**Request for Additional Information No. 463(5280, 5281), Revision 0,
Supplement 6**

U. S. EPR Standard Design Certification

Question 03.07.03-40:**Follow Up to RAI 370, Question 03.07.03-38**

Figure 03.07.03-40-1—Illustration of Impact Zone Criteria

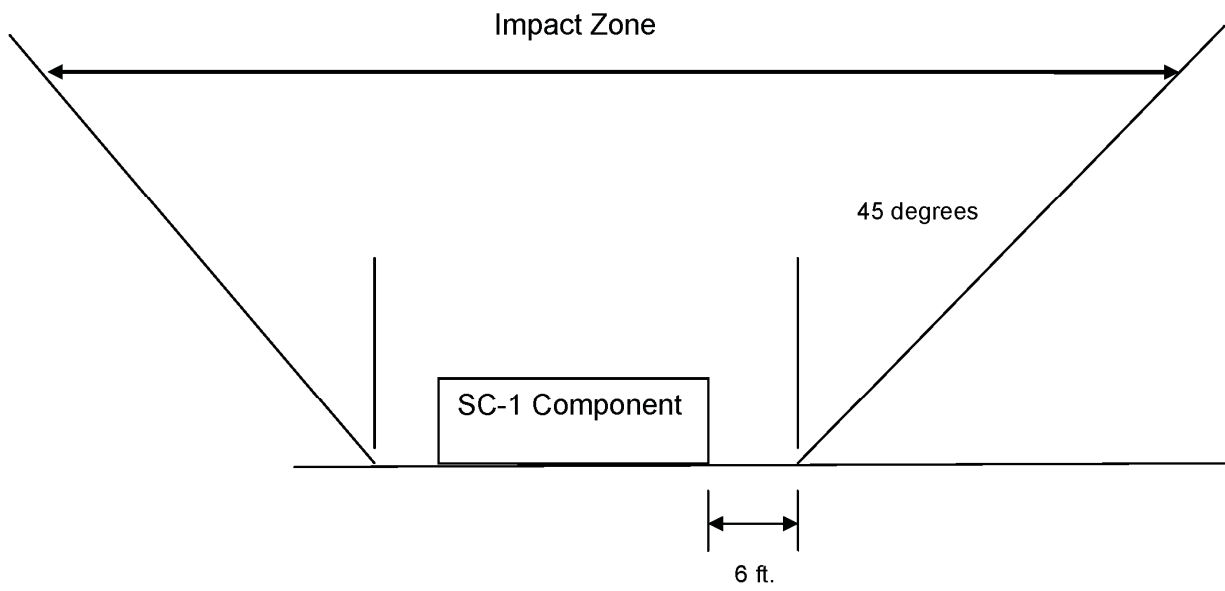
- a. The applicant is requested to provide the basis for assuming a 15 degree impact envelope above the SC I SSC and why this is a conservative assumption.

- a) The 15 degree impact envelope will be revised to include a six-foot buffer around the perimeter of a Seismic Category I component and extending upwards at a 45 degree angles shown in Figure 03.07.03-40-1. The additional six-foot buffer in conjunction with a 45 degree angle is considered adequate to protect any Seismic Category I component from a missile generated by a 1 g horizontal earthquake load simultaneous with a 1 g combination of vertical earthquake and gravity load.

U.S. EPR FSAR Tier 2, Section 3.7.3.8.2, will be revised to add the impact zone criteria.

The impact zone is defined by the volume extending in such a way that it is wholly or partially within a ~~15-degree angle from the vertical extending from each side~~ 45 degree angle beginning six feet beyond the perimeter of the Seismic Category I ~~subsystem or component~~ SSC. The impact zone for overturning includes the volume encompassed by the height of the non-Seismic Category I SSC and a radius extending from the perimeter of the non-Seismic Category I SSC to 1.5 times the height of the non-Seismic Category I SSC. The impact evaluation zone does not need to extend beyond Seismic Category I structures (e.g., walls or slabs).
